# UNITED STATES PATENT AND TRADEMARK OFFICE

10/527,898

<b>Office Action Summary</b>	<b>Application No.</b>	<b>Applicant(s)</b>	
	10/527,898	HAISCH, HANSJOERG	
	<b>Examiner</b>	<b>Art Unit</b>	
	JONATHAN M. HANSEN	2886

## **DETAILED ACTION**

FIG. 1

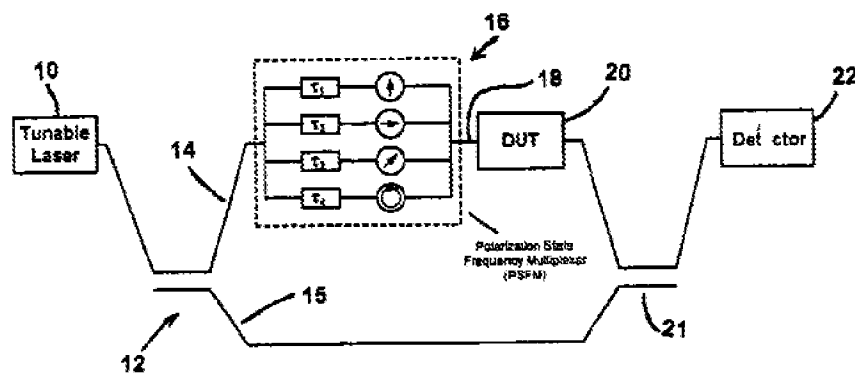
In regards to claims **1 and 7**, Friessnegg discloses and shows in Figure 1 below a method of polarization dependent analyzing an optical signal provided to a DUT, comprising the steps of:

using the optical signal as a measurement signal (14) of an interferometer (12) (col. 4, ll. 13-25),

splitting the optical signal at least into a first signal part having an initial first polarization and a second signal part having an initial second polarization (16) (col. 4, ll. 26-57),

delaying (applicant's coding) the first signal part using a first delay (applicant's first code) and delaying (applicant's coding) the second signal part using a second delay (applicant's second code) (col. 4, ll. 33-44),

providing the coded signal parts to the DUT (20) (col. 4, ll. 44-46),

superimposing a DUT-signal coming from the DUT in response to the delayed signal parts with a reference signal (15) of the interferometer to provide a resulting superimposed signal (21) (col. 4, ll. 51-56),

detecting the resulting superimposed signal (22) (col. 4, ll. 51-56), and

determining a first part of the DUT-signal corresponding to the first signal part by means of the first code and determining a second part of the DUT-signal corresponding to the second signal part by means of the second code (col. 4, ll. 57 to col. 5, ll. 33) (col. 2, ll. 30-33).

In regards to claim **2**, Friessnegg discloses and shows in Figure 1 above the method, further comprising the steps of:

additionally splitting the optical signal (14) into a third signal part having an initial third polarization and a fourth signal part having an initial fourth polarization (16),

delaying the third signal part using a third delay and delaying the fourth signal part using a fourth delay (16),

providing the first, the second, the third and the fourth delayed signal parts to the DUT (20),

detecting a DUT signal coming from the DUT in response to the coded signal parts (22), and

determining a first part of the DUT-signal corresponding to the first signal part by means of the first code and determining a second part of the DUT-signal corresponding to the second signal by means of the second code and determining a third part of the DUT-signal corresponding to the third signal part by means of the third code and determining a fourth part of the DUT-signal corresponding to the fourth signal part by means of the fourth code (col. 4, ll. 57 to col. 5, ll. 33) (col. 2, ll. 30-33).
